# Newmar Corporation Warranty Department

TSB Number: 380

### **Safety Recall Campaign Replacement of Bosch Service Brake Calipers**

**SUBJECT: Replacement of Bosch Service Brake Calipers**

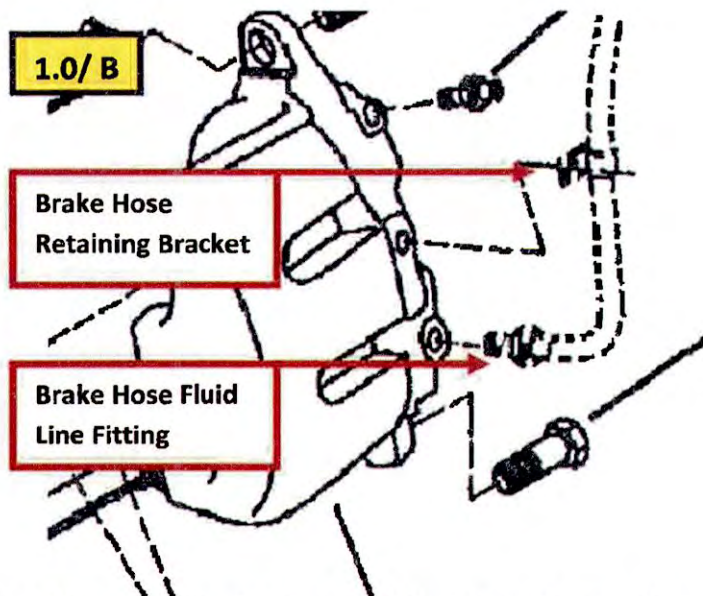
7. Remove the tool used to compress the caliper pistons.
8. Remove the brake hose retaining bracket fastener from the caliper. (View Illustration 1.0/ B)

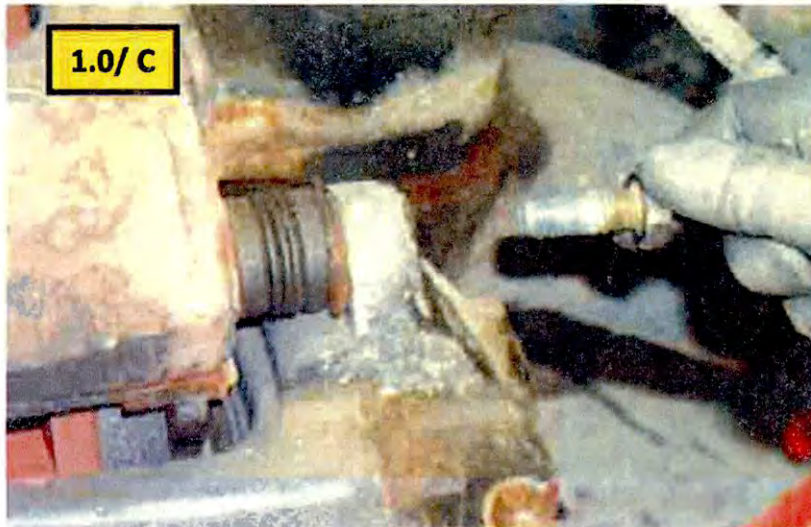
9. Disconnect brake hose fluid line fitting from caliper and cap off to prevent brake fluid leakage or contamination in the line. Do not allow the brake line hose to become pinched or kinked during the remedy procedure. (View Illustration 1.0/ B)
10. Remove the upper (top) caliper mounting bolt securing the caliper to the upper guide pin. (Shown in Photo 1.0/ C)
11. Remove the lower (bottom) caliper mounting bolt securing the caliper to the lower guide pin.

**1.1/C**

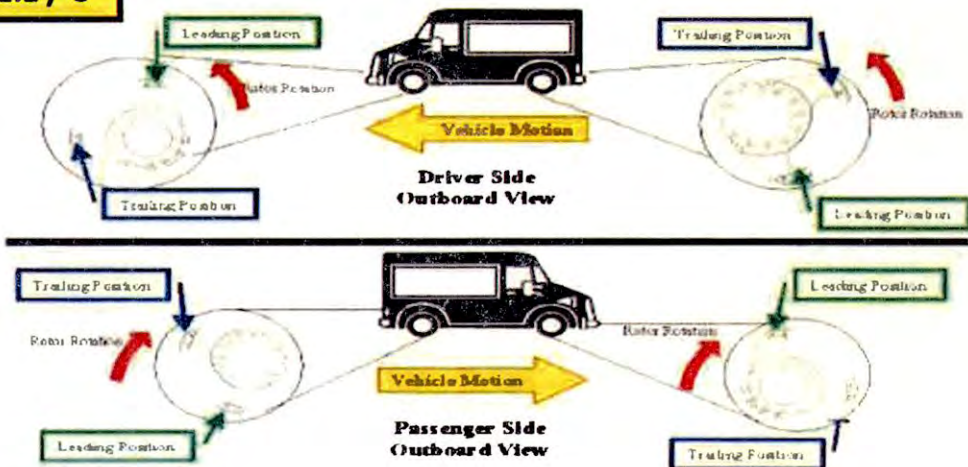
**IMPORTANT:** The ZOH-T leading bolt must be tightened first during the assembly process after both leading and trailing bolts are installed finger tight.

**Identifying Slide Pin Leading and Trailing Positions**

6. Torque the ZOH-T mounting bolts as follows:
  - a. Torque leading bolt to 93-107 lb-ft (126-145 N-m)
  - b. Torque trailing bolt to 93-107 lb-ft (126-145 N-m)
  - c. See Leading and Trailing bolt position illustration (1.1 / C)
7. Connect the brake hose fitting to the fluid inlet port on the caliper and torque to 14-17 lb-ft (20-24 N-m). (See illustration 1.0 / B)
8. Reconnect the brake hose retaining bracket to the caliper using the original bolt removed. (See illustration 1.0 / B)
9. Bleed brake system torque bleeder screw to 8-15 lb-ft. (10-20 N-m)
10. Install the tire and wheel assembly and torque the wheel lug nuts to 450-500 lb-ft.
11. Lower the vehicle.

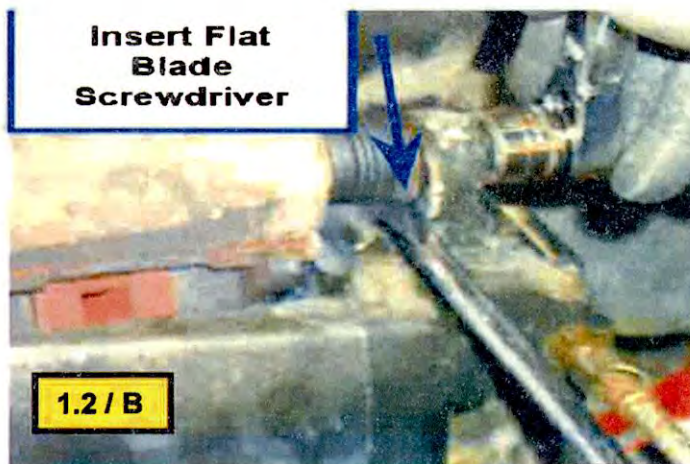
1. Inspect and lubricate the caliper slide pins with silicone brake grease.
2. When reusing the ZOH-T slide pin mounting bolt clean the threads and apply Loctite 2440 adhesive on bolt threads.
3. Align flat on upper (top) slide pin boss with the flat on the caliper housing upper (top) guide pin boss. Be careful when positioning caliper over disk brake pads, rotor and upper (top) guide pin to avoid tearing or dislodging piston boots or guide pin boots. (View Photo 1.2 /A)

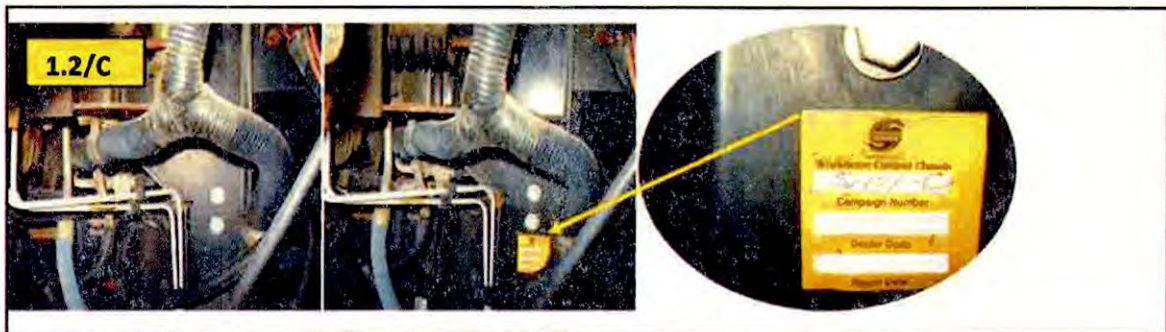
12. Complete the Recall Campaign Completion label and attach to the vehicle bulk head in a visible area near the chassis fuse box / Maxi Booster mounting bracket (Shown in photo 1.2/ C). One completion label (PN W8001493) will be shipped with every two caliper kits ordered.
